Summary Design Modifications April 2018

Need and Purpose Statement

2014 to 2018

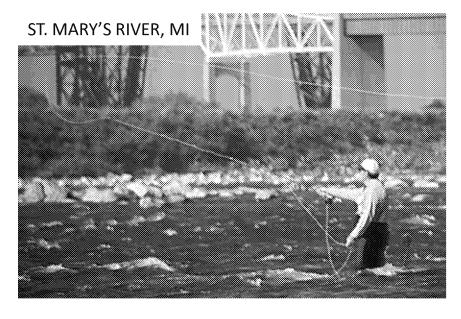
- Modifications to the design were in an effort to further naturalize and "soften" parts of the proposed hydraulics
 - This was done by converting wave features to riffles and runs which emulate conditions similar to Michigan reference reaches
- Safety, fishing access, circulation, and aquatic habitat complexity for fish and mussels were specifically considered in all design modifications

2014 to 2018

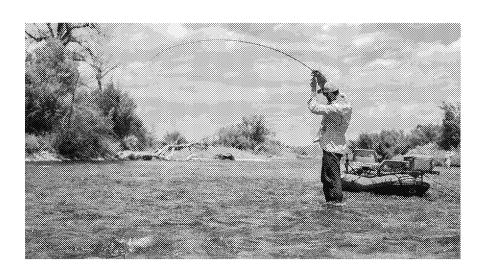
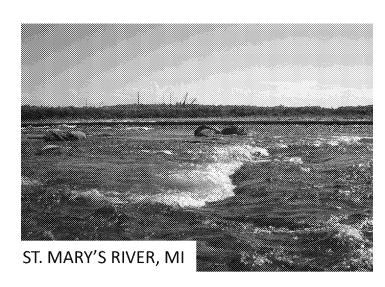
- Channel-spanning structures have been minimized by shifting the control locations on one side of the river either upstream or downstream
- The addition of more riffle features made of cobble and boulder to distribute the gradient on the east side of the channel
- Within the gently sloped riffle areas of the river, some larger boulder were added and the elevation of the riffle was variably graded.
 - This is in order to maintain some depth at lower flow rates and to maintain naturalized rapid functionality and aesthetic

2014 to 2018

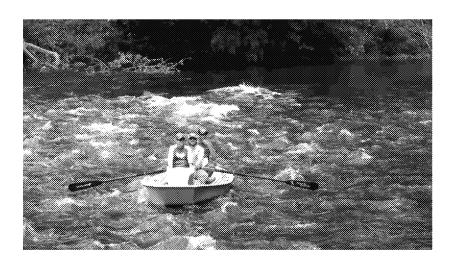
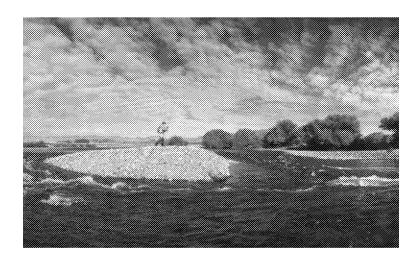
- Some wave features on the west side of the river were re-graded to be gradual riffles or runs
 - Specifically the features in front of the Public Museum and between Gillett and Pearl Street
 - Wave features have been reduced from 15 in 2012 to 8 in the current design
- The eight wave features that remain in the design, including the three large wave features near the dam, were diversified and reduced in width.
 - The additional area created by this reduction has been designed to be either a riffle, run, or boulder garden feature
- Diversity of flow direction was also enhanced to further naturalize the function and aesthetic of the reach

2014 to 2018 6TH Street Dam to I-196

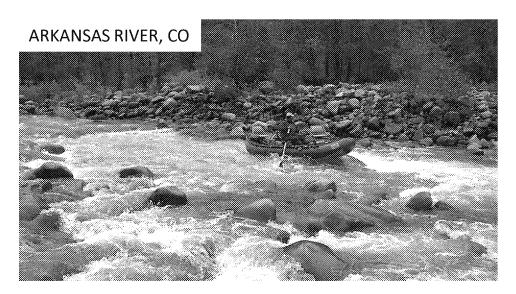
- A higher level of grading detail has been added to the center of the channel to better evaluate and accommodate fish passage and improved habitat.
 - Less average invert elevations are shown on plans and more specific locations of changes in elevation across a given invert are detailed
 - Specific input driving these updates were in regards to providing areas of relatively deep flow with low velocities for fish passage
- Gently sloped (2.5%) cross-flow between the two sides of the channel has been added through detailed grading
 - This was in an effort to maximize fish passage functionality and the natural aesthetic of the reach
